APPLICATION NO.	FILING DATE	FIRST NAMED INVENTOR	ATTORNEY DOCKET NO.	CONFIRMATION NO.
09/647,700	10/03/2000	Birgitte Hansen	36636-166652	1109

Office Action Summary

DETAILED ACTION

FIG. 7

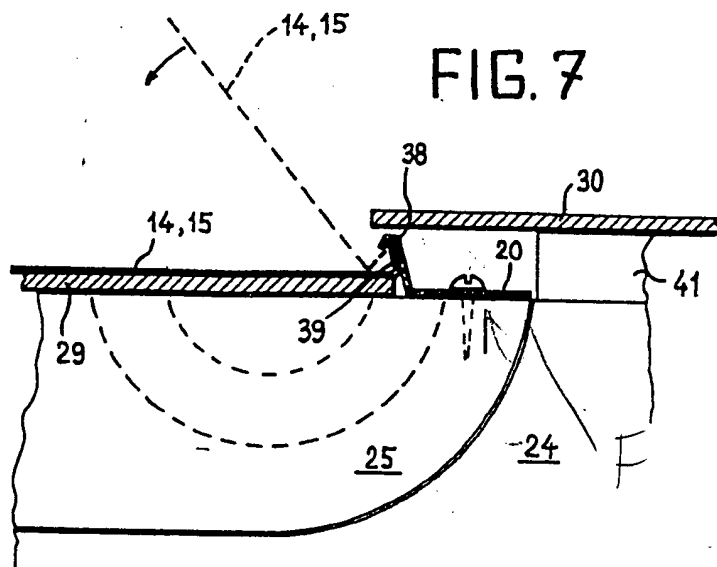
6. In lieu of the 35 USC 112 rejections noted above, claims 1-3,7 and 10 are rejected under 35 U.S.C. 102(b) as being anticipated by Swedish Patent #374578. 374578 discloses the use of a window including top as at (12), a bottom as at (13) and opposing side members as at (10,11) wood profile members covered by a weather shield cover (12,13,14,15), engaging and securing means (20,21); wherein the weather shield cover includes an upper cap (16a-c), an interior glazing profile (41), an exterior cover member (13) and a cap member (14,15) that has an integral bent and hidden engagement means (B), see the marked attachment of Figure 8. Regarding claim 2, the cap (14) pivots, see figure 7. In reference to claim 3, the cap is secured to an upper

portion (12) a lower portion (13) and side portions (15) of an opening (11) by fasteners (F) and securing means (20,21) and (38), see marked attachment. The cap member consists of an upper cap (16a-c) and lower caps (14,15). Regarding claims 7 and 10, the cap is U-shaped with integral bottom (B) and side walls (S).
